Access Compliance Report Public Rights-of-Way (Pedestrian Signals)

Main Street: **CHAPMAN_AVE** Cross Street: **CANNON_ST** Location: **NW**

ADA ID: **SGRK220103111313** Signal Type: **One Push Button-Non APS** Overall Compliance: **No** Severity Scores: **BTN 1: 35** **BTN 2: N/A** **No BTN: N/A**

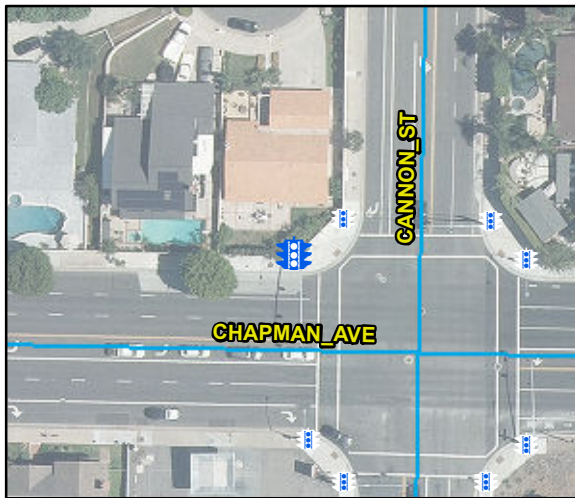
Yes	B 1 Diameter (in)	2	N/A	B 2 Diameter (in)	N/A
N/A	B 1 Crossing Direction	S	N/A	B 2 Crossing Direction	N/A
No	B 1 DistanceTo XWalk (in)	86	N/A	B 2 DistanceTo XWalk (in)	N/A
No	B 1 DistanceTo Curb (in)	83	N/A	B 2 DistanceTo Curb (in)	N/A
	Parcel Identification Number	379-345-16			
	Google Street View Link				
	http://www.google.com/maps/@?api=1&map_action=pano&viewpoint=33.7878338,-117.79602074

Possible Solutions: Replace Signal Push Button With APS Button. Remove & Relocate Sign.

OC Std/PROW: MUTCD 4e.08, R404.2, R404.3
